Applicants : James A. Yurko et al.  
Appln. No. : 10/761,911  
Page :

In the Drawings:

REMARKS

FIG. 2

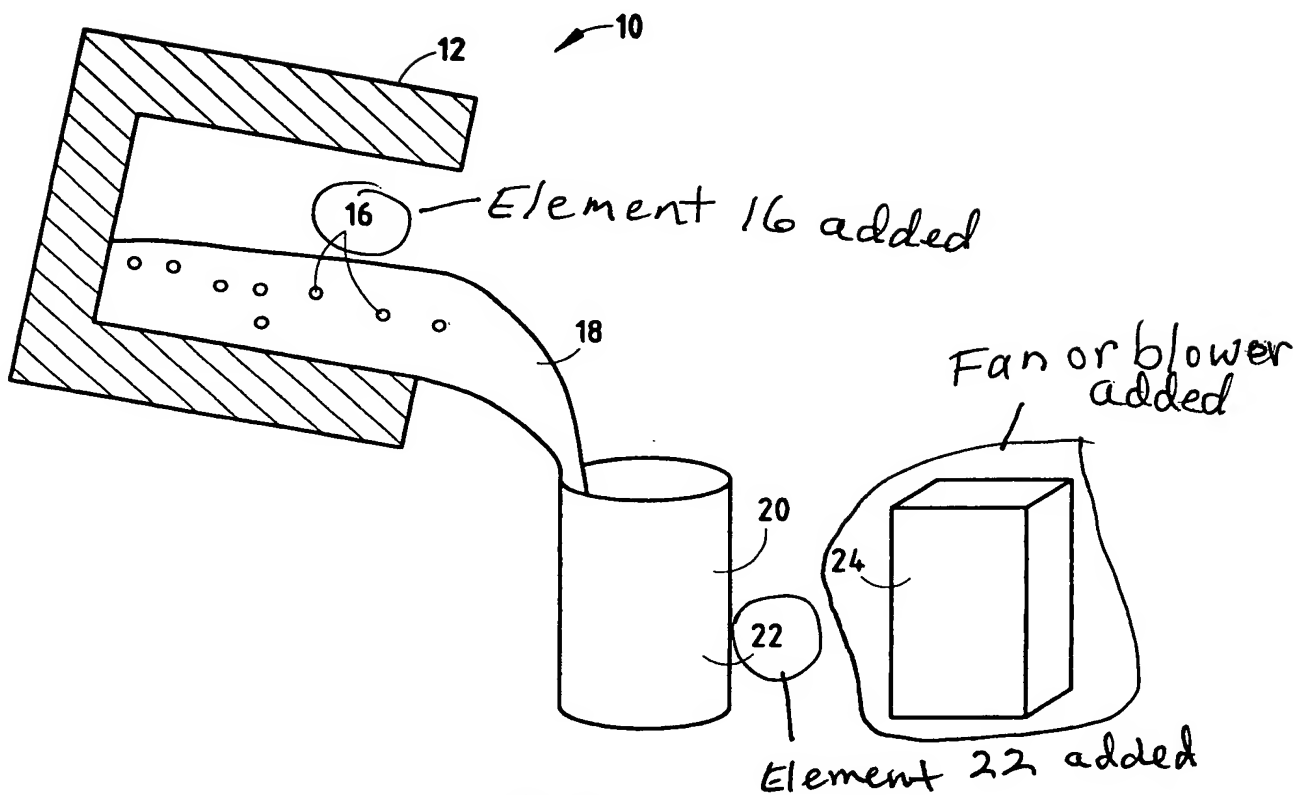
The attached drawing sheet includes changes to Fig. 2. This sheet, which includes Figs. 1-2 replaces the original sheet including Figs. 1-2. Fig. 2 has been amended to include fan or blower 24 and to identify walls 22 as disclosed in the specification at paragraph 0029.

Applicants are enclosing a replacement sheet to in which Fig. 2 has been amended to include fan or blower 24 and to identify walls 22 as disclosed in the specification at paragraph 0029.
